SHEET NAME: UTILITIES AND DRAINAGE SHEET	
PROJECT NAME: JOHNSON	HIGHWAY NO.: TH 2
PROJECT NUMBER: BHO 1448(18)	BRIDGE NO.: 6
	OVER: THE LAMOILLE RIVER
FILE NAME: /strl/90j067/sj067ut.dgn	PLOT DATE: 02-SEP-2005
PROJECT MANAGER: R. WHITCOMB	DRAWN BY: S. MAGNAN
DESIGNED BY: C. MEUNIER	IPARM NAME: sc067dr.i
BRIDGE SHEET NUMBER:	SHEET 16 OF 73

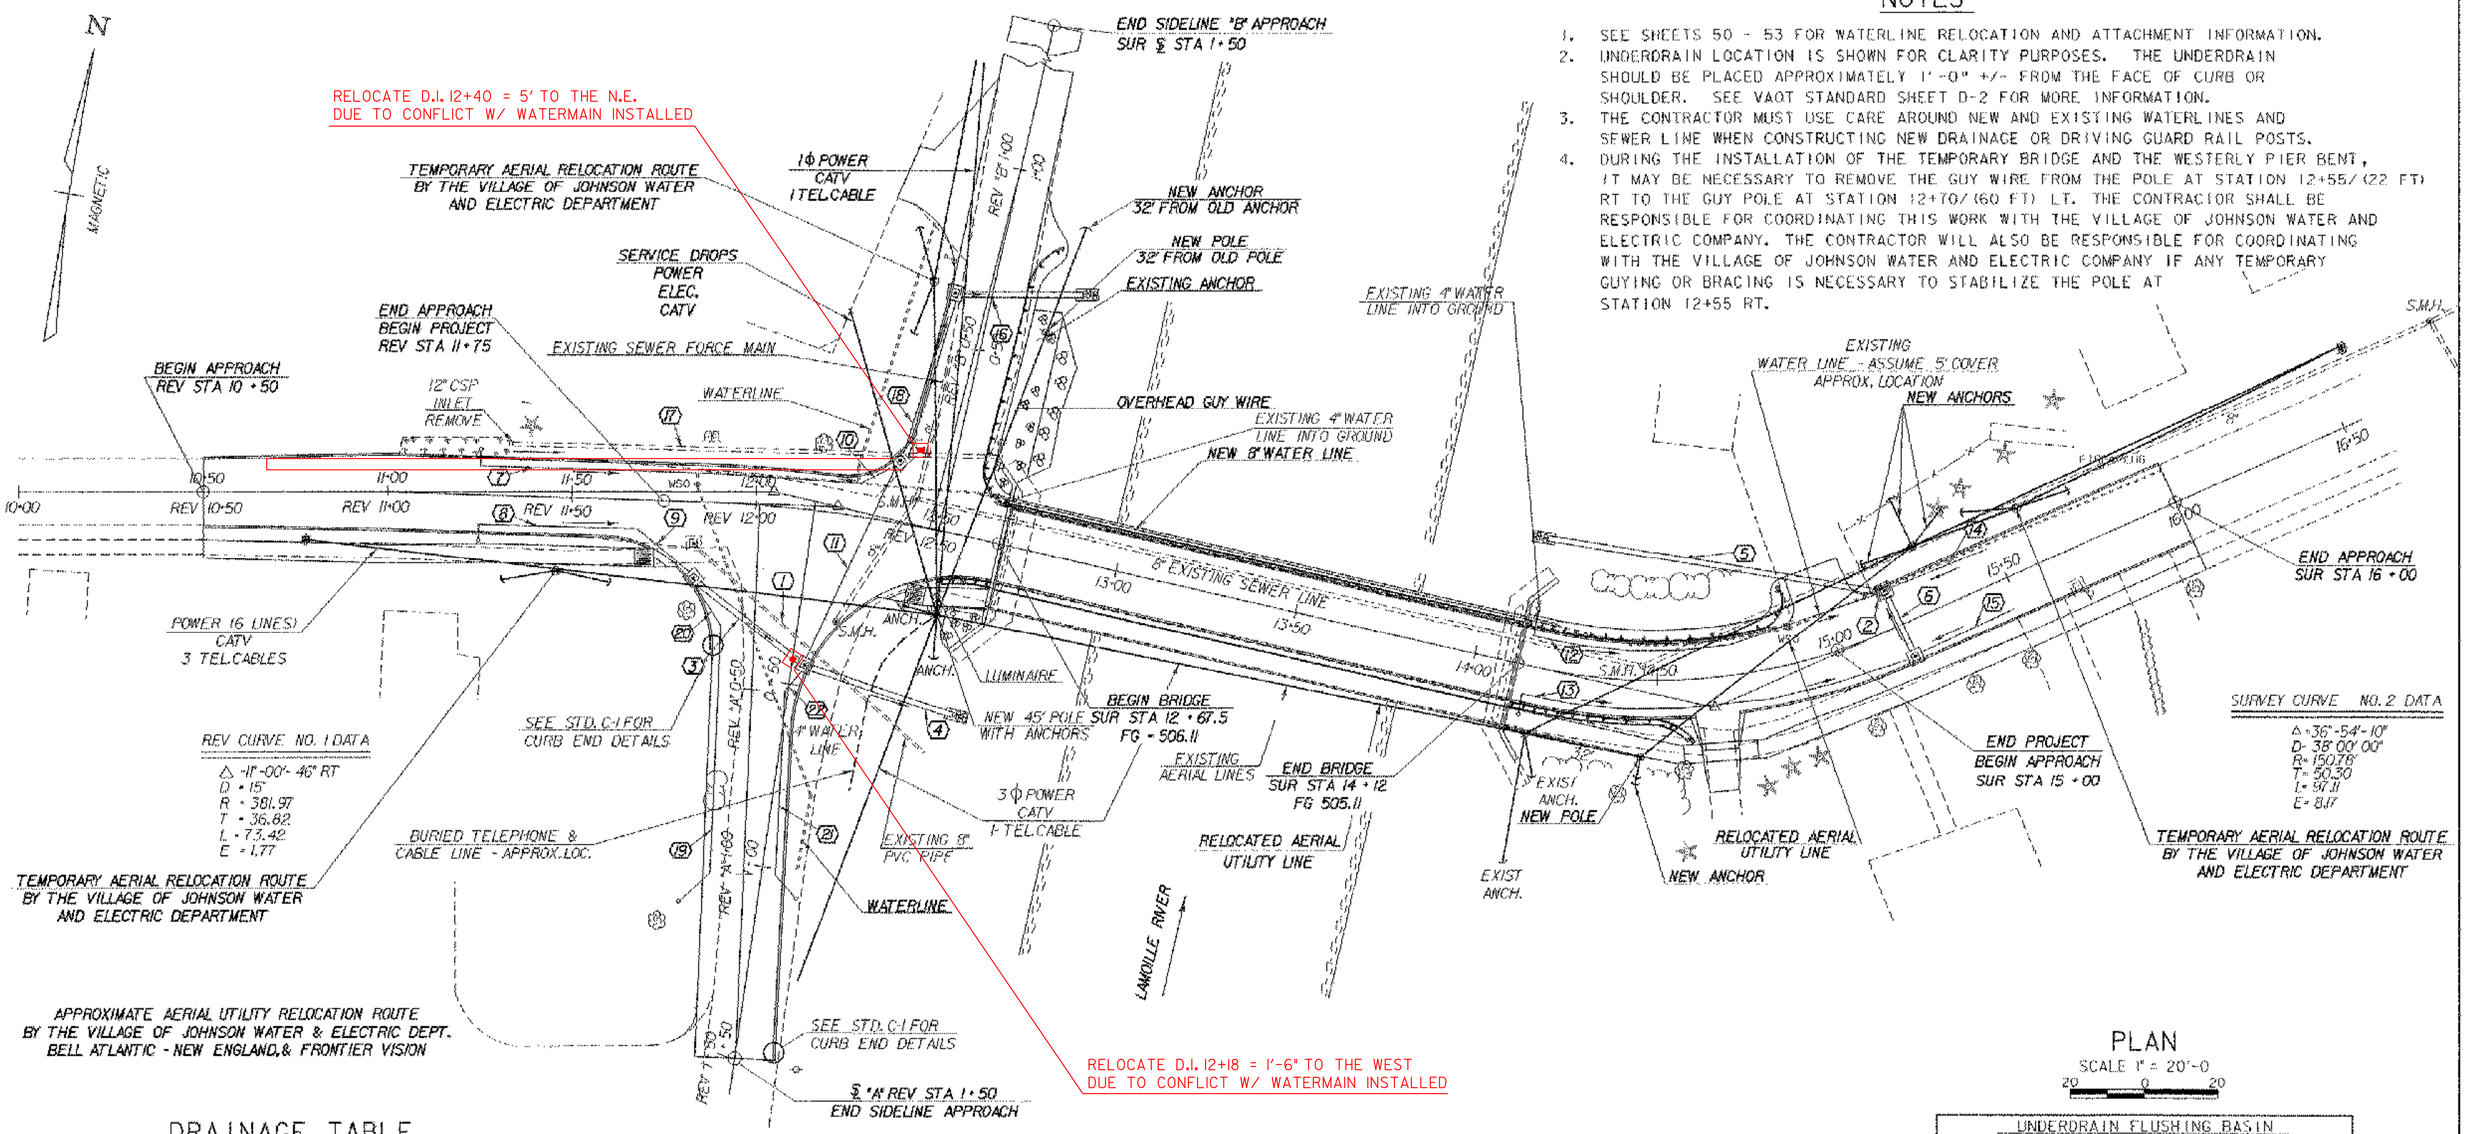
NO.	STATION	DESCRIPTION	NO.	STATION	DESCRIPTION
1	REV 11+83 RT ~ SUR 12+60 RT	REMOVE EXISTING 8" X 82' PIPE AND D. I.	11	~~REV 12+40 LT ~ REV ℄ "A" 0+42 LT~~	~~NEW 6" x 58' UNDERDRAIN~~
2	SUR 15+18 LT	REMOVE EXISTING D. I.	12	SUR 14+13 LT ~ SUR ~~15+16~~ LT 14+89	NEW 6" x ~~96'~~ UNDERDRAIN 76
3	REV 11+84 RT ~ REV 12+18 RT	NEW 18" x 36' PIPE (OPTIONS A, B, C, & D) WITH 4' x 4' D. I. WITH TYPE E GRATE AT INLET	13	SUR 14+~~13~~ RT30 SUR 15+~~16~~ RT 20	NEW 6" x ~~106'~~ UNDERDRAIN 110
			14	SUR 15+18 LT ~ SUR 15+~~50~~ LT 46	NEW 6" x ~~34'~~ UNDERDRAIN 26
4	REV 12+18 RT ~ SUR 12+66 RT	NEW 18" x 42' PIPE (OPTION D & E) WITH 4' x 4' D. I. WITH TYPE E GRATE AT INLET AND ~~6'~~ 10' x ~~3'~~ 20' STONE PAD, TYPE 1 AT OUTLET	15	~~SUR 15+18 RT ~ SUR 15+50 RT~~	~~NEW 6" x 34' UNDERDRAIN~~
			16	REV ℄ "B" 0+64 LT ~ REV ℄ "B" 0+71 RT	NEW 18" x 34' PIPE (OPTIONS A-D) WITH 4' x 4' DI WITH TYPE E GRATE AT INLET AND 6' x 3' STONE PAD, TYPE 1 AT OUTLET

5	SUR 14+~~12~~ 25 LT ~ SUR 15+17 LT	NEW 18" x ~~92'~~ 76' PIPE (OPTION D & E) WITH 4' x 4' D. I. WITH TYPE E GRATE AT INLET AND 6' x 3' STONE PAD, TYPE 1 AT OUTLET	17	REV 11+34 LT ~ SUR 12+67 LT	REMOVE EXISTING 12" x 137' PIPE
6	SUR 15+17 LT ~ SUR 15+17 RT	NEW 18" x 18' PIPE (OPTION A, B, C, & D) WITH 4' x 4' D. I. WITH TYPE E GRATE AT INLET	18	REV 12+40 LT ~ REV ℄ "B" 0+64 LT	NEW 18" x 46' PIPE (OPTIONS A-D) WITH 4 x 4 DI AT INLET WITH TYPE E GRATE
7	REV 11+25 LT ~ REV ~~12+28~~ 11+89 LT	NEW 6" x ~~104'~~ UNDERDRAIN 56	19	~~REV ℄ "A" 0+33 RT ~ REV ℄ "A" 1+10 RT~~	~~NEW 6" x 68' UNDERDRAIN~~
8	REV 11+25 RT ~ REV 11+68 RT	NEW 6" x ~~44'~~ UNDERDRAIN 42	20	~~REV ℄ "A" 0+22 RT ~ REV ℄ "A" 0+33 RT~~	~~NEW 6" x 14' UNDERDRAIN~~
9	REV 11+68 RT ~ REV 11+84 RT	NEW 6" x 20' UNDERDRAIN	21	~~REV ℄ "A" 0+42 LT ~ REV ℄ "A" 0+50 LT~~	~~NEW 6" x 8' UNDERDRAIN~~
10	~~REV 12+28 LT ~ REV 12+40 LT~~	~~NEW 6" x 10' UNDERDRAIN~~	22	REV ℄ "A" 0+50 LT ~ REV ℄ "A" 1+10 LT	NEW 6" x ~~50'~~ UNDERDRAIN 60
